General Bid Bulletin No. 17
07 July 2021

RESPONSES TO CLARIFICATIONS

IFB No. 21-058-5; South Commuter Railway Project for Package Number CP S-03b; Civil Engineering, Tunnel and Building Works for Approximately 6.1km Railway with 4.7km of Underground Railway and 1.4km of At-Grade Railway, Including FTI Station and Tunnelling Works to Connect to MMSP Senate Station

CATENARY SUPPORT POST- TYPICAL DETAIL(REFER NOTE 4)

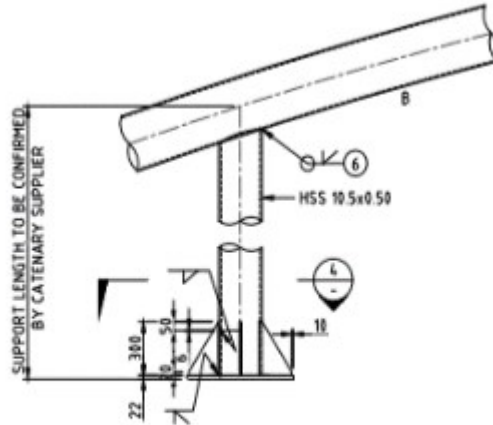
15		Volume 1A Section 4A Bill of Quantities Detailed Design Structural Drawings	Section 4A Bill of Quantities	Bill No. 5 NSRP- DWG-FTI- ST-4411	Item No. 408(14) Structural Steel (For Additional Support of Overhead Catenary Contact System) FTI Station Steelwork Roof Details-Sheet 1	Catenary Support Post-Typical Detail	<p>In NSRP-DWG-FTI-ST-4411, there is a typical detail for catenary support, however it is indicated in Note 4 in the same page that catenary support details is still for confirmation. Kindly provide its finalized details. Refer to Annex 1.</p>	<p>For Catenary Support Post refer to the revised drawing NSRP-DWG-FTI-4411 rev.21.3, which will be issued with Bid Addendum 3 and the specifications. Please refer to Bill 5 Pay item 408(14) Structural Steel (For Additional Support of Overhead Catenary Contact System)</p>
16		1.3 CP S-03b Vol 1A	Sec 4A BOQ 20210406	Bill No. 6a	Item No. 528(35)	N/A	<p>Please specify location of W12: W=4050mm x H=1650mm Fixed Steel Louver for West Station Plaza.</p>	<p>Schedule W12 was removed due location will be having duct works equipments. See window schedule NSRP-DWG-FTI-AR- 3563, rev 21.2 dated 20 May 2021. Pay item 528(35) will be deleted in Bill 6a in the BOQ and submitted with Bid Addendum 2.</p>
